Access Compliance Report Public Rights-of-Way (Curb Ramps)

Main Street: KENWOOD_LN Cross Street: SIERRA_ALTA_DR Location: SE

ADA ID: RPAT211013083951 Ramp Type: Type 6 - Directional 1 Initial Pass/Fail: Pass Overall Compliance: No Severity Score: 4

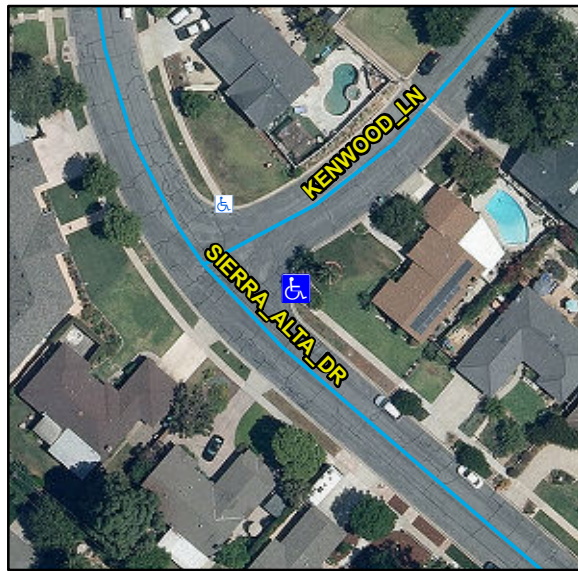
R304.2.1, STD 1115

Remove & Replace Landing.
